**From:** Beltz, Terry  
**Sent:** Sunday, August 23, 2015 7:41 PM  
**To:** 'Michael K Scarpello'; hlkish@aep.com  
**Cc:** Alley, David; Tsao, John; Pelton, David  
**Subject:** Donald C. Cook Nuclear Plant, Unit 2 - Proposed Alternative to the ASME Code, Section XI, Repair Requirements  
**Attachments:** Socket weld.docx

The NRC staff has requires additional clarification related to your August 23, 2015, request associated with the Indiana Michigan Power Company (I&M) proposed alternative to the American Society of Mechanical Engineers (ASME) Code, Section XI, repair requirements to apply a weld overlay, with a deviation from ASME Code Case N-666, to a defect in the boric acid makeup system piping. Please refer to the attached document regarding socket welds.

**(c-1) Slip-On Flange [Note(3)]**

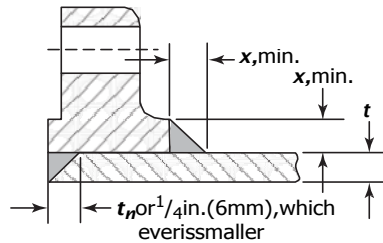
Item C-1 (two drawings on left) are slip-on flanges. Item C-2 (single drawing on right) is flange socket weld. Item C-3 is another socket weld. The August 23, 2015, application indicates the affected component is socket weld FW-17. However, based on the attached drawings, the drawing supplied in Section 7 of your application does not clearly represent a socket weld. This, at the very least, indicates that the I&M may require two alternatives from the code case: 1) a mechanism other than fatigue, and 2) apply socket weld code case to a weld that is not a socket weld.

Therefore, the NRC staff requires a better drawing of the subject component to clearly indicate if it is a slip-on flange or a socket weld flange. In other words, if this is a socket weld then a better drawing is requested. If it is not a socket weld, then you need to revise your request to reflect that the weld in question is not a socket weld and provide further discussion regarding that alternative to the code case.
